ARCHITECTURAL REVIEW COMMITTEE
AGENDA
February 5, 2015
7:30 a.m.

1. Call to order
2. Approve minutes of November 14, 2014
3. Request for amendment to the Industrial Park Architectural Tier Map for Simonson Lumber 3855 Independence Road.
4. Other Business
5. Next regular scheduled meeting is February 19, 2015
6. Adjournment

Simonson Lumber

ARC Standard	Required	Actual	Comments
Exterior material	SeeE3	Architectural Metal Non-Architural Metal,	100% Arc metal on front façade. New style deviated from original approval and the existing buildings.
Size/Mass	Proportion	Size/Mass ok	Proportionate to Surrounding
Articulation – S. side	60 foot max.	N/A	OK.
Articulation - E. side	"	N/A	OK
Articulation – W. side	"	N/A	OK
Articulation – N. side	"	Centered at 40 ft.	Created by piers each end and center. Need a clear detail and type of material.
Accessory Structures	Similar materials	N/A	N/A
Color	Earth tone	Tan/Brown	OK
Height/roof design	Flat or 6:12+	1:12	Variance for roof pitch
Mechanical equipment	Screened; not visible @ Height of 5 feet 100 Feet from bldg.	N/A	Unconditioned structure
Evaluation of Design	Relationship Compatibility	Similar to neighboring bldg	OK

DWG. A3.1

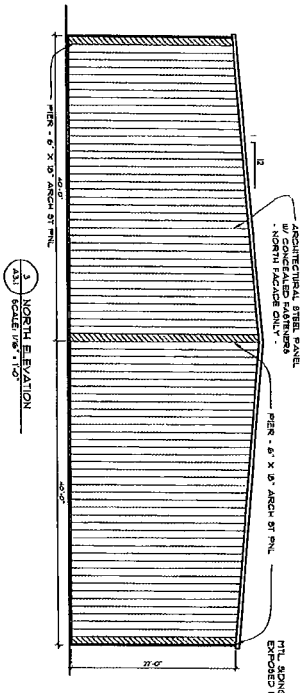
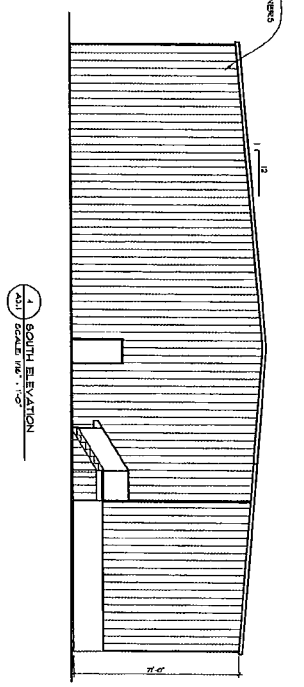
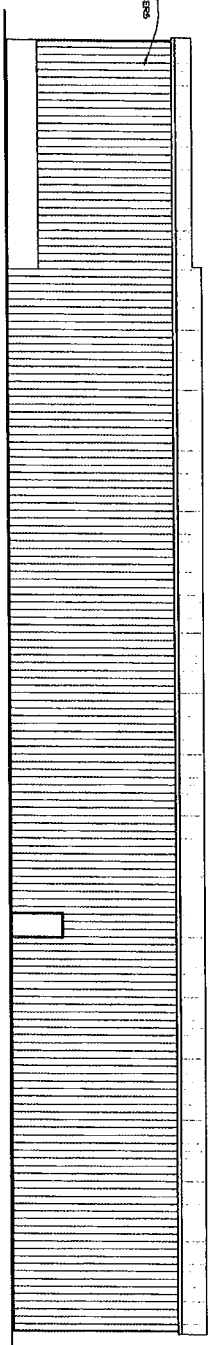
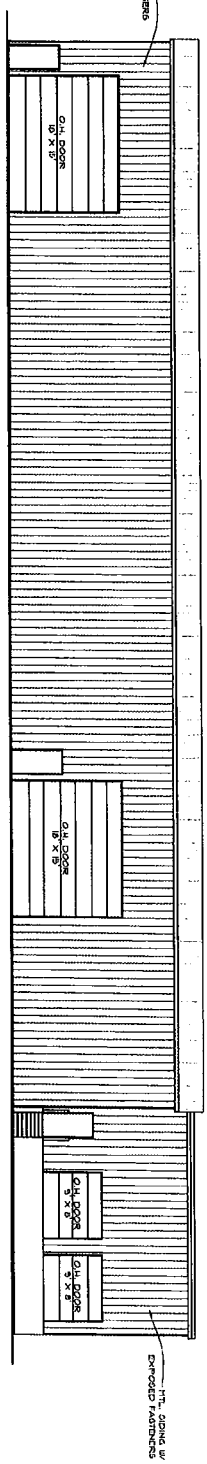
Staff can support a change to tier II for the property which would allow non architectural metal with exposed fasteners on the side and rear elevations. However the applicant is also proposing to deviate from the architectural metal that was proposed at the time of the variance and to deviate from the articulation that was proposed at the time of the variance. The variance for the roof pitch was based on a plan with a door and eyebrow on the North side of the building. Staff cannot recommend approval of a plan that has a style change from the variance approval.

Staff recommendation: Staff cannot recommend approval based on findings.
